CALIFORNIA COASTAL COMMISSION

STAFF REPORT: AMENDMENT

APPLICATION NO: 5-87-983-A2

PROJECT LOCATION: 26025 Pacific Coast Highway, City of Malibu, Los Angeles County

Exhibit 10
 Permit Amendment
 5-87-983-A2 (Forge)
 ALTERNATIVE 1

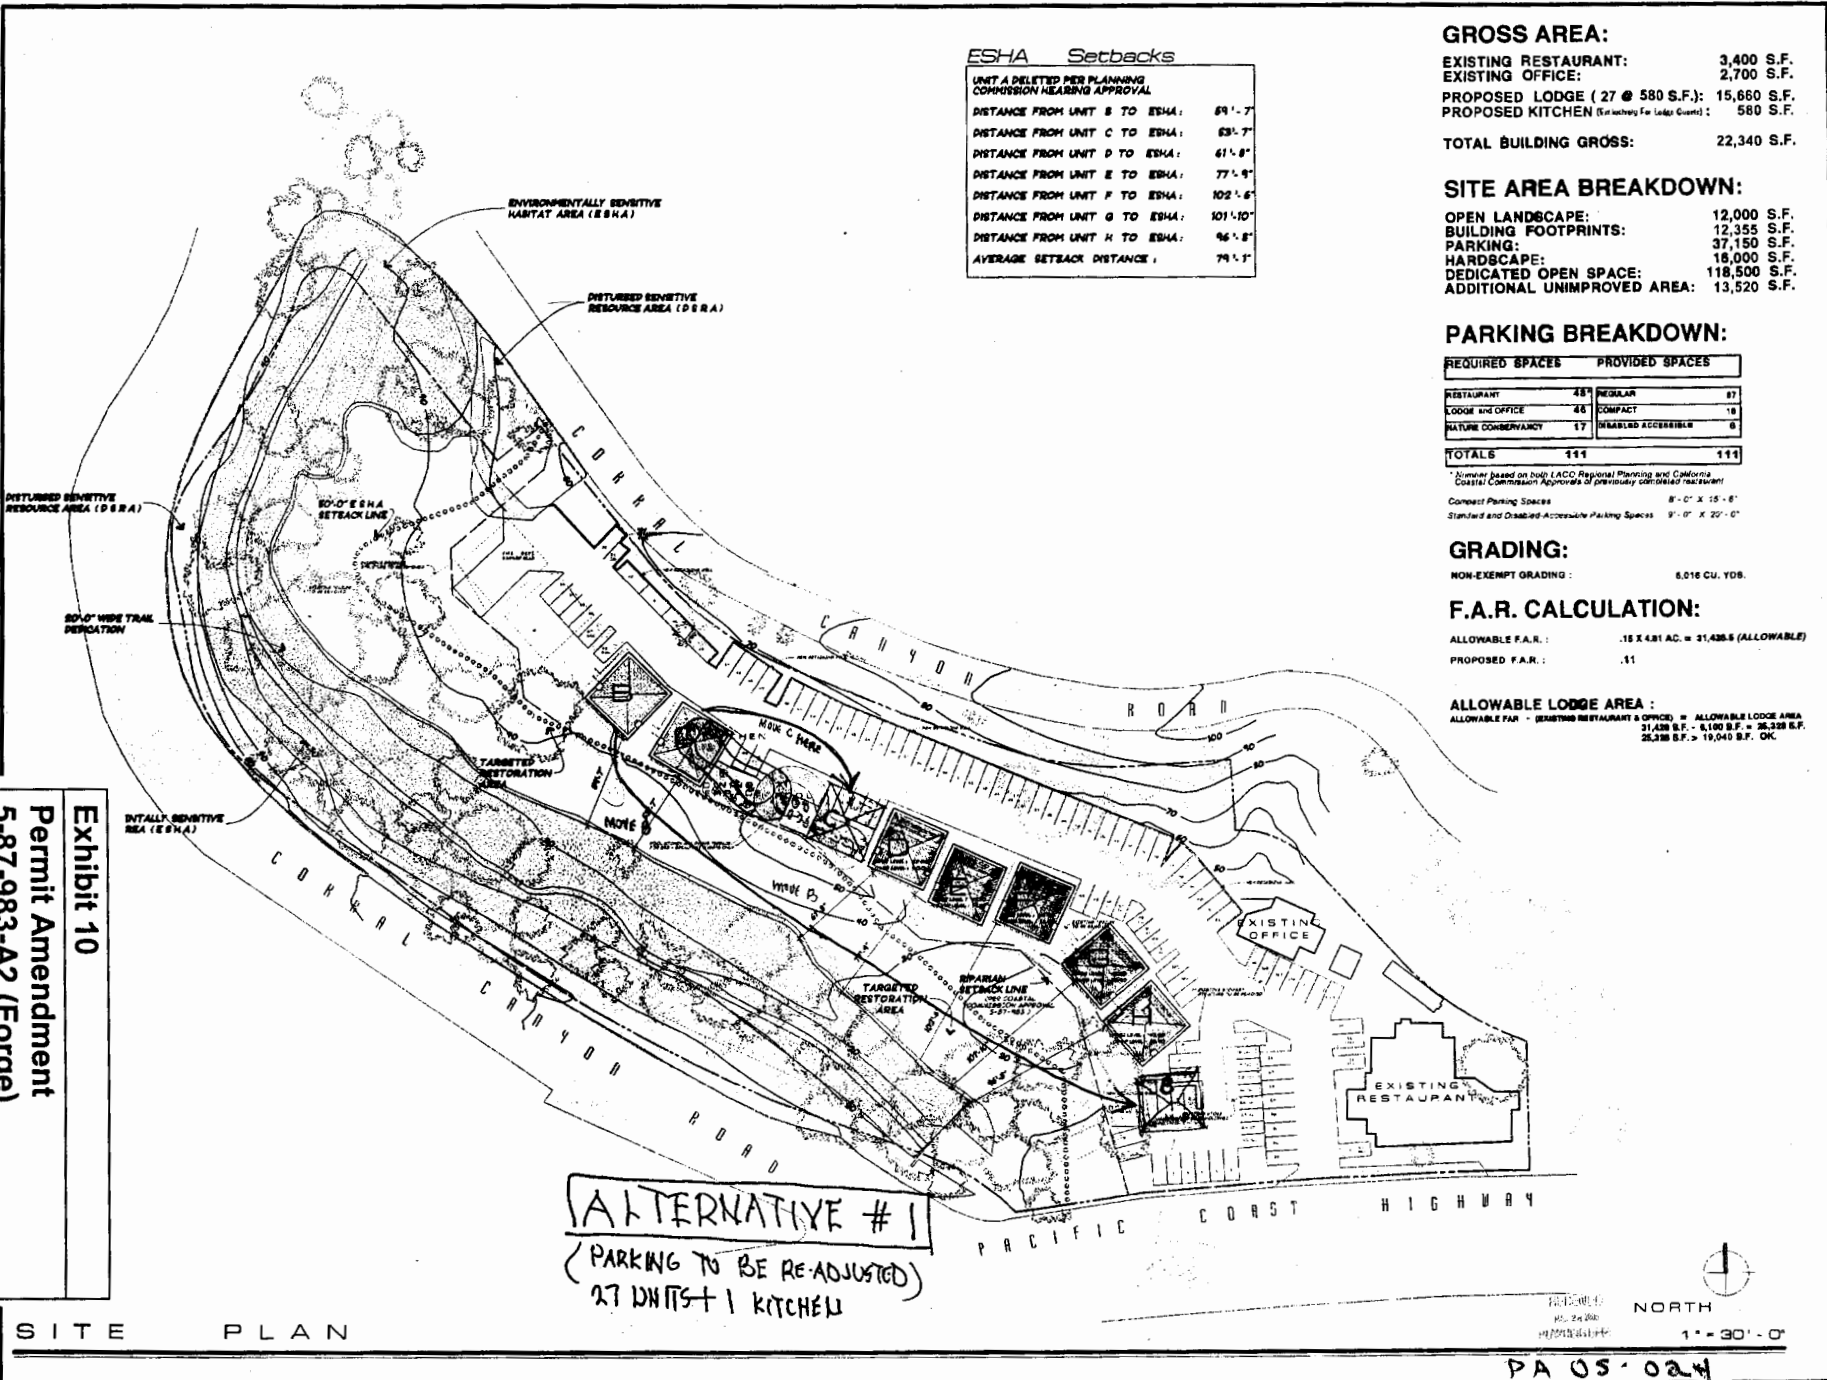
Alternative No. 1 (shown in Exhibit 10) would shift the seven structures closer to Pacific Coast Highway by relocating Building B to within 40 feet of the street. Building C would be relocated next to Building D, and the pool would be moved. This alternative would require the approval of a minor modification by the City of Malibu in order to reduce the setback from the required standard of 65 feet down to 40 feet. This alternative would cluster the proposed structures closer to the developed area of the site, and increase the ESHA buffer provided. In this case, the smallest buffer would be increased from 53 feet, 7 inches to approximately 60 feet. Five buildings would provide a buffer of at least 100 feet.

SITE PLAN

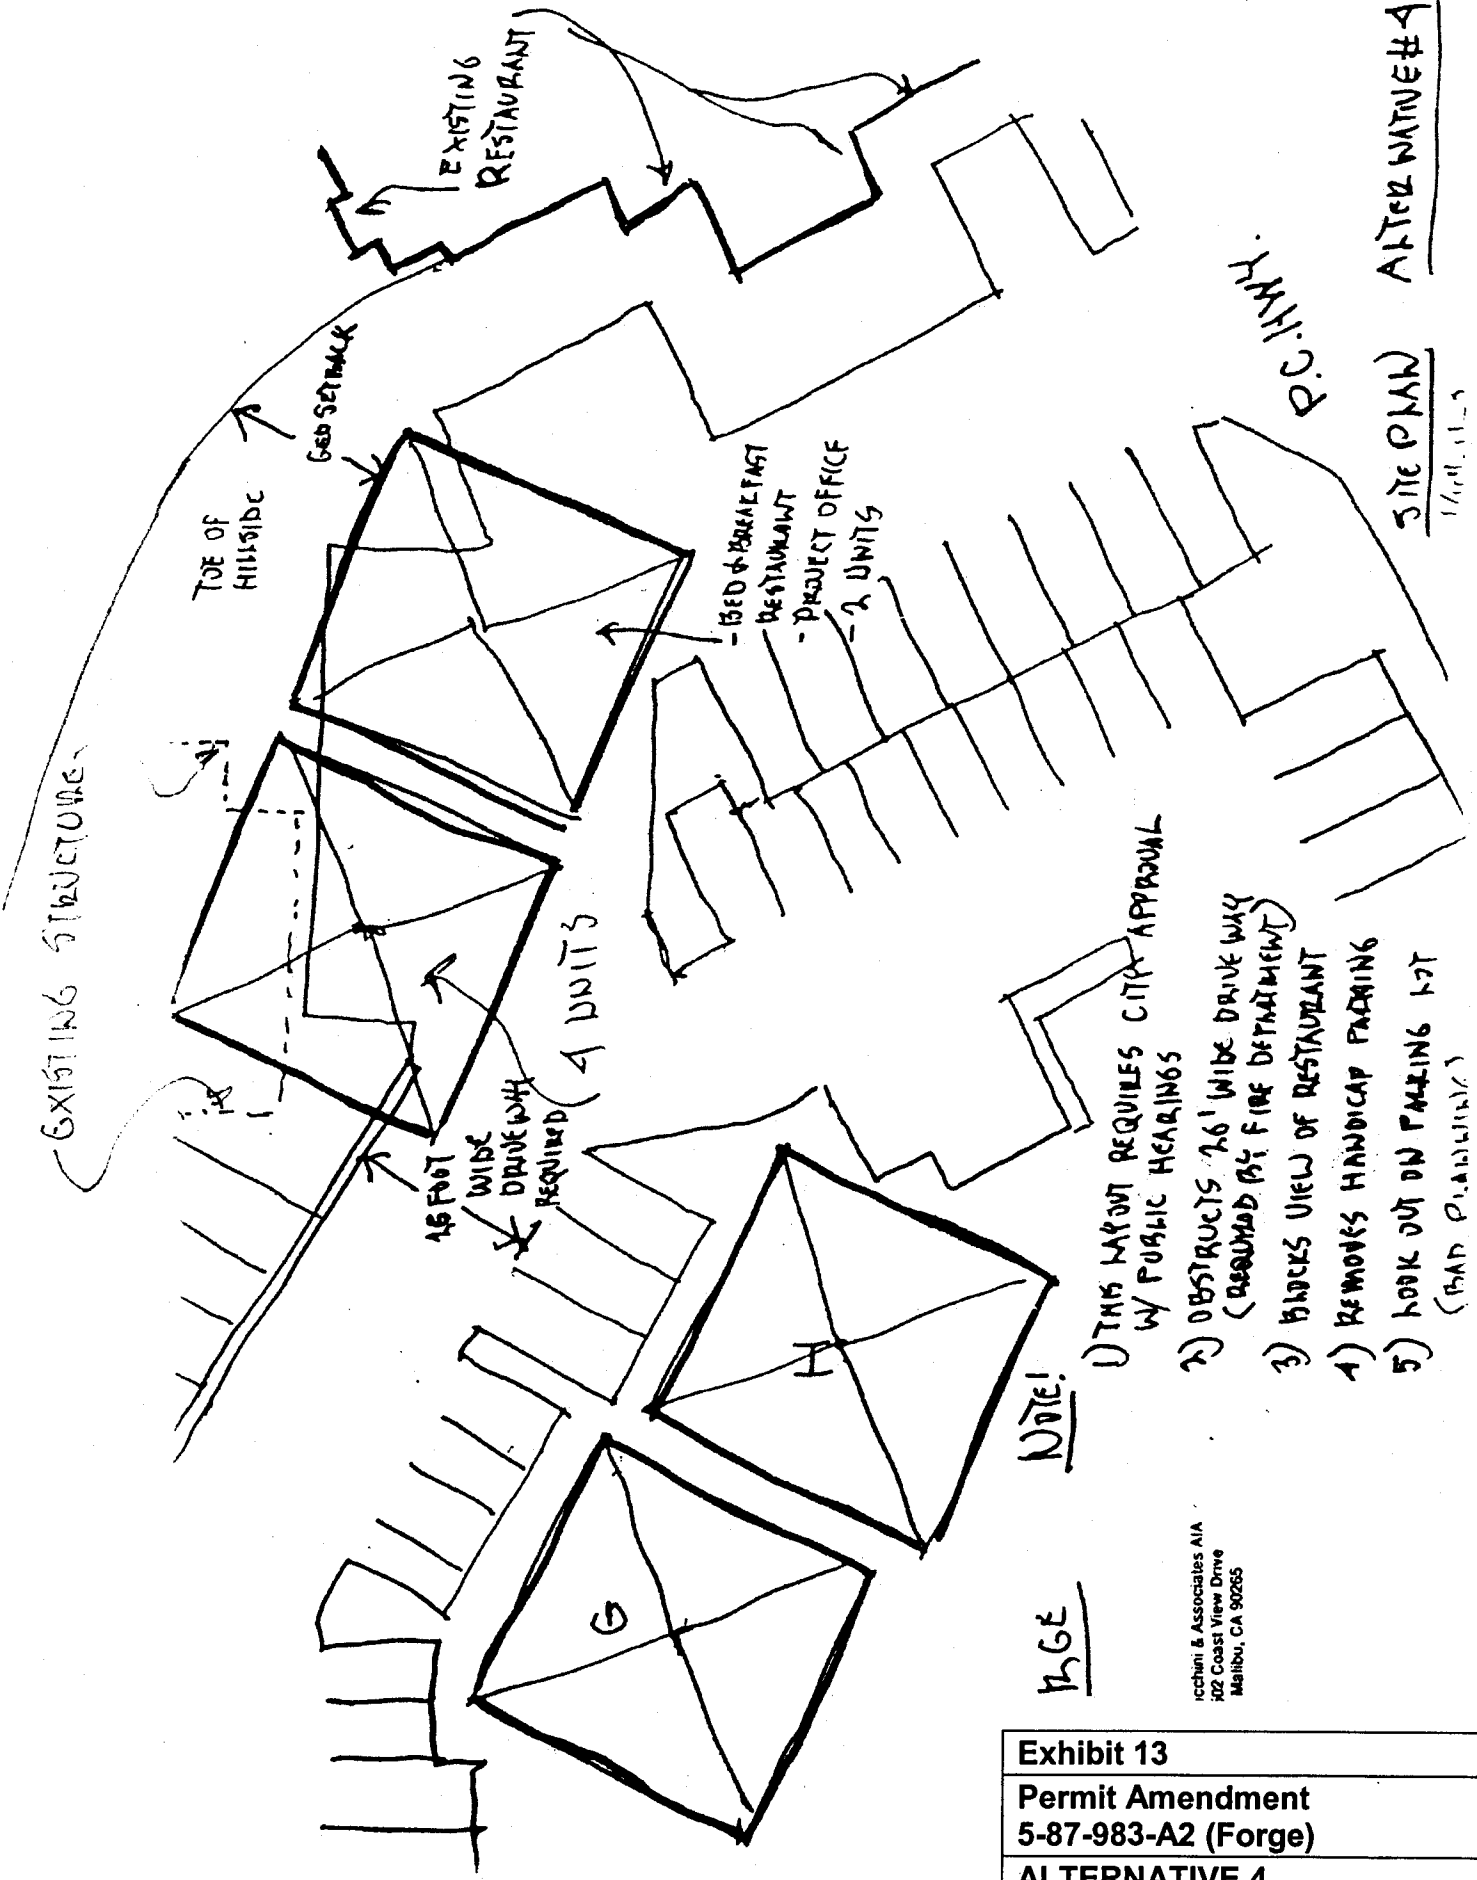
- 1) THIS MAP/NOT REQUIRES CITY APPROVAL W/ PUBLIC HEARINGS
- 2) OBSTRUCTS 26' WIDE DRIVEWAY (ASSUMED BY FIRE DEPARTMENT)
- 3) BLOCKS VIEW OF RESTAURANT
- 4) REMOVES HANDICAP PARKING
- 5) LOOK OUT ON PARKING LOT (BAD PLANNING)
